## 2 Type of change

All product types listed in section 1 receive a new label layout.

Product Change Notification					Global Labeling Ph. 3 Voltage Selector		
owner	creation date	release date	released by	change order no	rev	page	D10-056-053
vetersa	12.03.2021	15.03.2021	haeckima	2021676	A	1 of 2

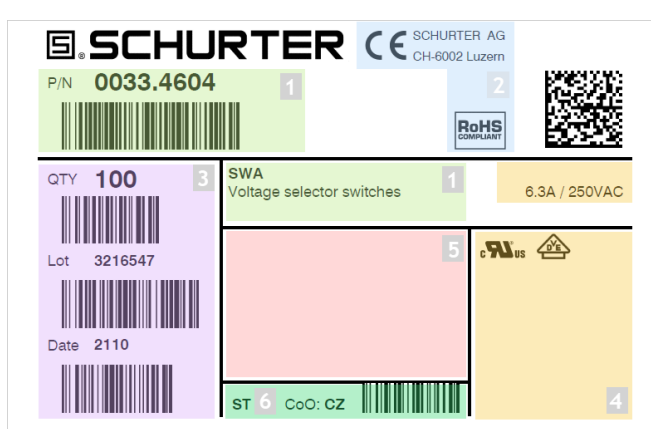
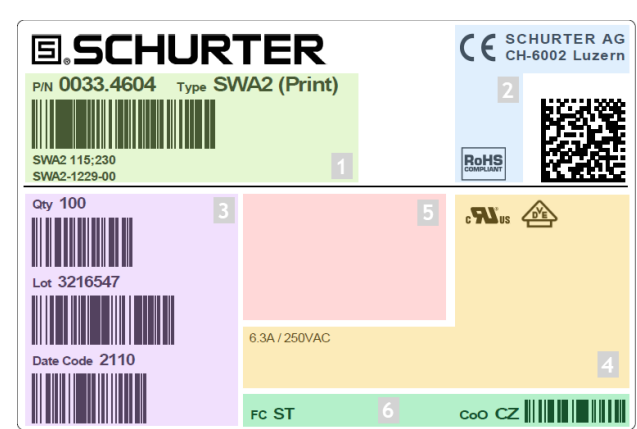
- Modified label
- Improved identification product configuration code on the label

<b>Product identification section:</b> To improve readability, we clustered all the information concerning product identification in this group. To increase clarity, we introduce our product configuration code into this area.	1
<b>Product conformity section:</b> Identical information was slightly rearranged.	2
<b>Product logistics section:</b> Label names changed. Information was slightly rearranged.	3
<b>Product approval section:</b> Identical information was slightly rearranged.	4
<b>Interruption ratings section:</b> Identical information was slightly rearranged.	5
<b>Origin information section:</b> Label for Factory Code was added. Information was slightly rearranged.	6
